Product Change Notification - SYST-21DDQK199

ERRATA - PIC32MX320/340/360/440/460 Family Silicon Errata and Data Sheet Clarification

PIC32MX534/564/664/764 Family Silicon Errata and Data Sheet Clarification

FIGURE 1: EXTERNAL COMPARATOR SCHEMATIC EXAMPLE

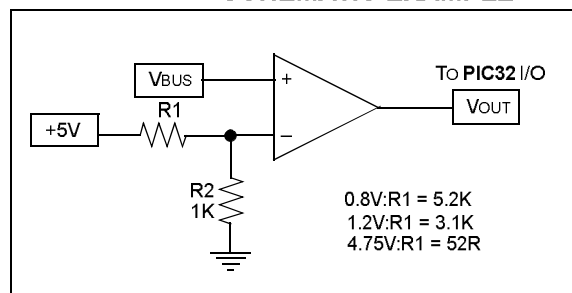
16. Module: USB

When the USB model is configured for OTG operation, it may not recognize all required OTG voltage levels on VBUS pin.

Work around

Use external comparator circuit to detect OTG specific voltage levels on VBUS pin.
